# West Hills Neighborhood Council

RE: Case #ZA-2024-5222-CU2-ZBA

Site Location: 23717 Victory Boulevard, West Hills, CA 91307

RE: Proposed project/New Starbucks with Drive-Thru Service 23717 Victory Blvd West Hills, CA 91307

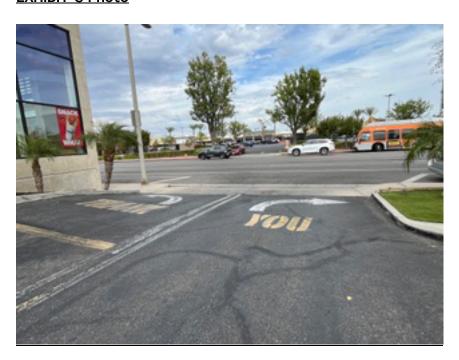
There will be more pollution and noise from vehicles because of the large number of customers using the drive-thru waiting to purchase and receive drinks and food.

Additionally, two power poles have not been removed from the Starbucks site, possibly the electronics were removed.
